FILE IN _____ SK _____ MANUAL(S).	
	SERVICE BULLETIN	Supersedes: Nothing
		File with Form: 160.65-OM1

SUBJ.: LOSING VAR. SET POINTS
ON THE 1250 TON SCREW

FOOTPRINT (note the number starting with V62C5 and the circle with 9 dots)

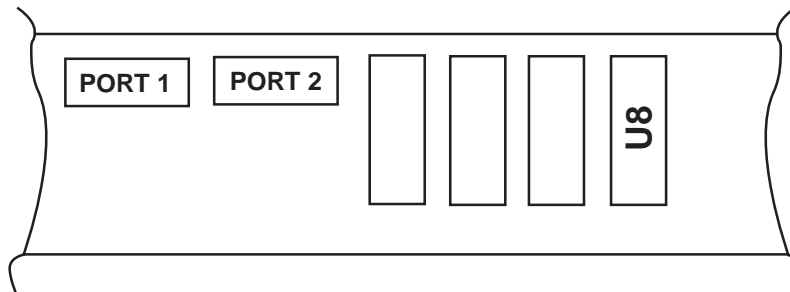
PROBLEM: On the 1250 ton screw chiller the panel loses its variable set points for no apparent reason.

SOLUTIONS: The problem is the U8 chip on the micro board. To resolve this problem you must replace the micro board. You will find below a drawing (footprint) of the defective chip. If the footprint is as shown below the chip is your problem.
